3817 JENIFER ST NW

BZA PRESENTATION

September 2026

Board of Zoning Adjustment
District of Columbia
CASE NO. 21452
EXHIBIT NO. 43

existing
view facing north

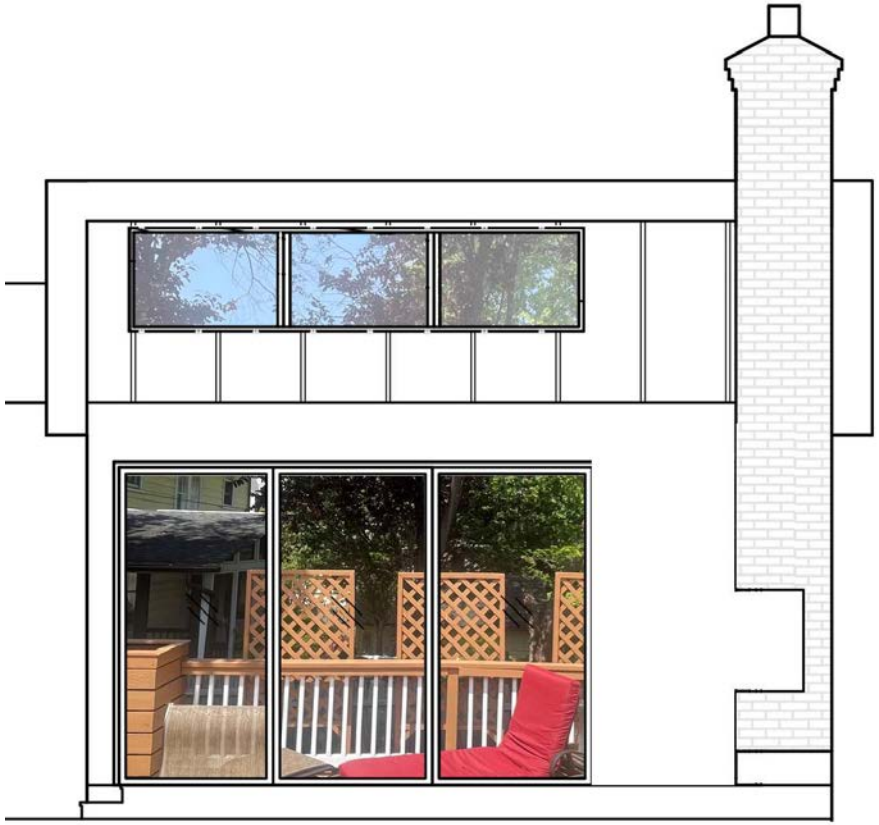
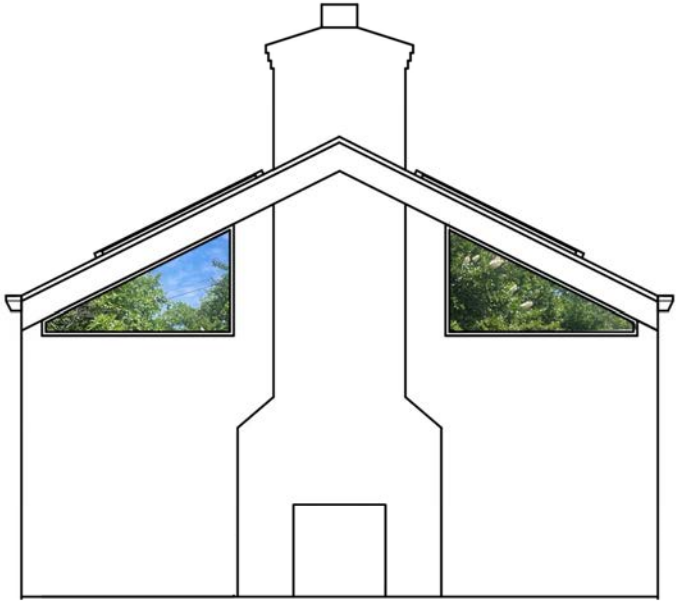
- The applicant has proposed building two large windows facing the alley, at second-story height, which would create direct sightlines into our backyard, which includes an outdoor living area on a deck, a side yard, and private living spaces, including rear rooms, dining room, kitchen, living room, and two second-story bedrooms. Other neighbors who sit across the alley from the applicant, like us, would be similarly impacted.

Privacy - We are providing more privacy not less. See response above.

View of the current rear of 3817 Jenifer Street from our master bedroom window

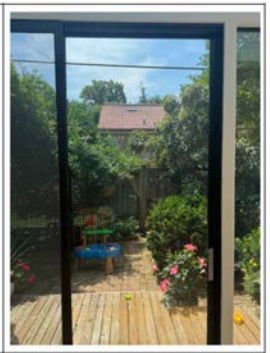
The rear of 3817 Jenifer currently faces our garden and rear-facing windows, including the windows of our master bedroom, our daughter's bedroom and our dining room. However, the existing structure is set back far enough that there remains some meaningful separation and privacy. The rear of the property currently has only one small window directly visible from our property. We have attached photos showing the current view from our dining room and from our master bedroom window.

The plans show a new living area built over the existing garage/deck, with large windows on the alley-facing elevation facing directly across the alley toward our property and other Jocelyn Street properties. For our home, that would create direct sightlines into areas where we currently have a reasonable degree of privacy, including our master bedroom, daughter's bedroom, dining room and rear garden.

We ask that the Board review the attached photos and the proposed elevations carefully when considering whether the proposal would unduly affect the privacy and enjoyment of our home and garden.

The images above show the east side of 3817 Jenifer St NW. No addition is proposed for this side of the house. Our proposed 1 story addition is on the west side of the property and protected by tree cover. The area above the garage is currently a deck with open sightlines. The proposed addition would limit the visibility towards the alley as well as, rear and side neighbors. The neighbors at 3814 Jocelyn NW will received more privacy, not less. Please reference the existing vs proposed sightlines at addition slide | facing north.
